CERTIFICATE OF APPROPRIATENESS PLACARD

516 EUCLID STREET

014-15-MW

Louis Cherry & Marsha Gordon
516 Euclid proposal for Minor Work:

Original COA Application Drawing indicating use of slate cladding:

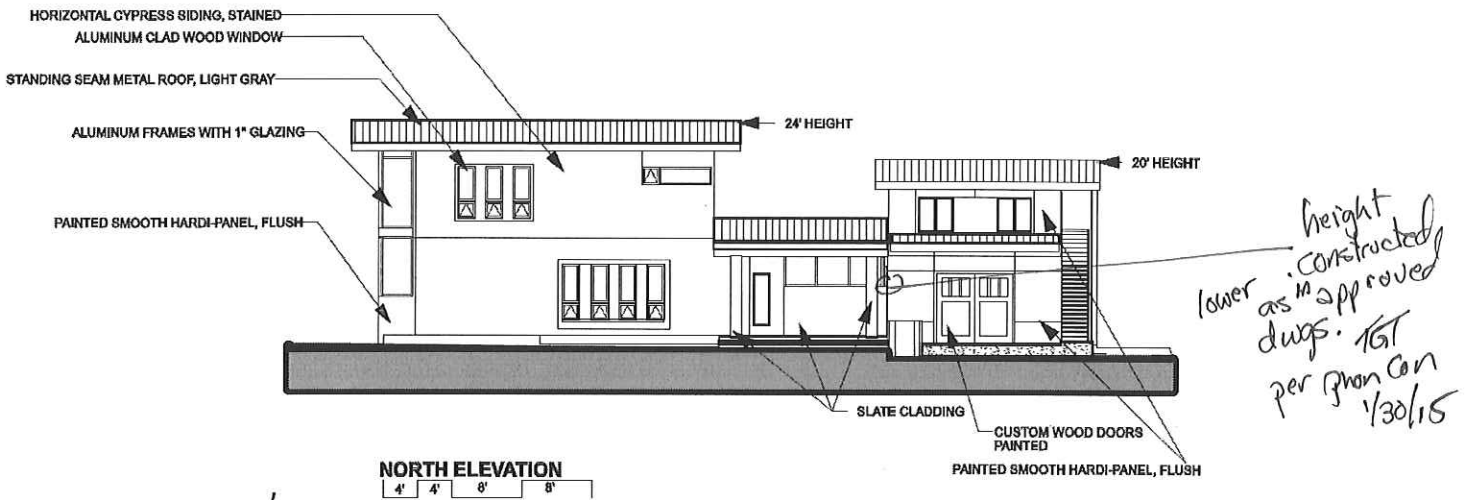
1) Our original approved submission for RHDC COA (135-13-CA) proposed slate cladding on the front porch columns, planter box, and exterior walls that enclose the screen porch (see below for drawing included with original COA application). The slate was changed, by the recommendation of the RHDC, to black brick, which we have used as recommended for the porch columns, planter box, and porch detailing.

We now propose to change the vertical surfaces of the porch from brick to smooth painted hardie-panel, installed in the same fashion as on the rest of the house. The brick would appear out of place here since the screened in porch connects on both sides with hardie-panel walls. Affected areas will be visible only on the north and west, as indicated in the attached elevations (highlighted to indicate where we propose the change from brick to hardiepanel).

Our original COA submission drawing (pasted below) indicates where we had originally proposed the slate cladding. Per the RHDC COA approval, brick was substituted for the slate for the columns, planter box, and front porch detailing (which are completed). We are requesting that hardiepanel, installed in the same fashion as on the rest of the home, be used only for the unscreened vertical areas as shown in more detail the attached drawings.

2. We would like to request that the "custom wood doors painted" in the original COA application (also visible in the drawing above) be changed to unpainted custom wood doors. The front door of the house is painted, and so leaving the garage doors unpainted sets them apart from the main entrance to the house. Using unpainted wood is also truer to the craftsman inspiration for the design of the home.

1 WEST ELEVATION
A107 1/8" = 1'-0"

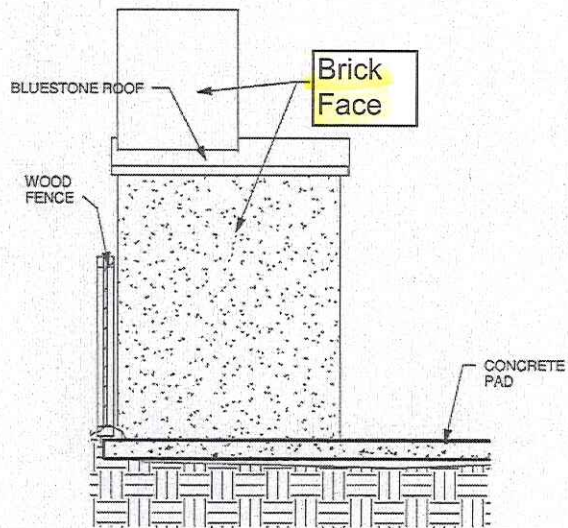
only solid part -

screening.

remove per 1/30/15 phone conv.

Per 1/30/15 phone conv. TGT

1 Wood Oven Side
A107 1/2" = 1'-0"

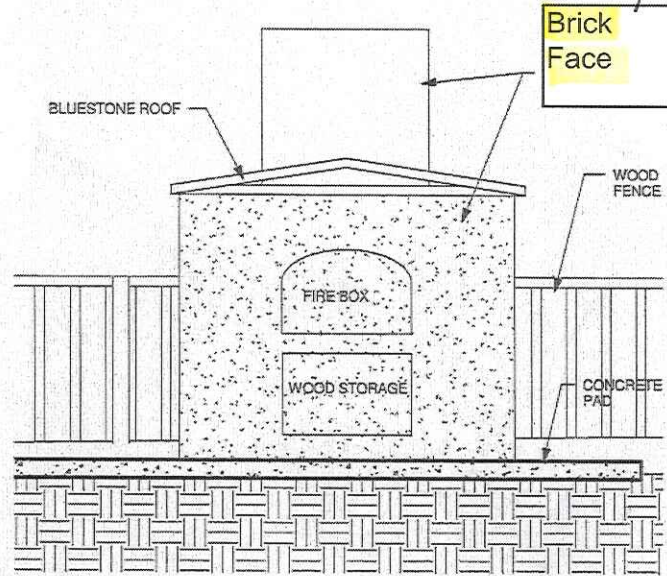
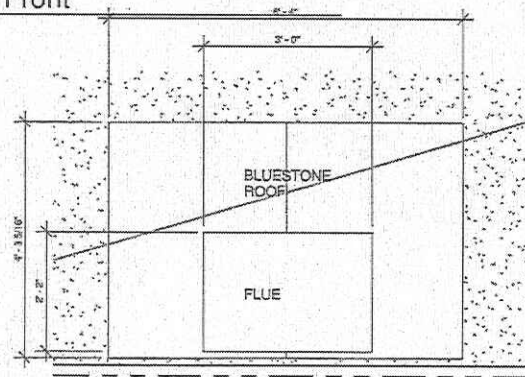
3. We would like to request a material change in our approved pizza oven (included in COA-004-14-CA). We request using brick instead of concrete, which is the most common material that has been approved for numerous other pizza ovens in Oakwood. Will use brick to match front porch

if available, 1/30/15

constructed
heights same
as approved,
per phone call
1/30/15
TGT

A same as porch
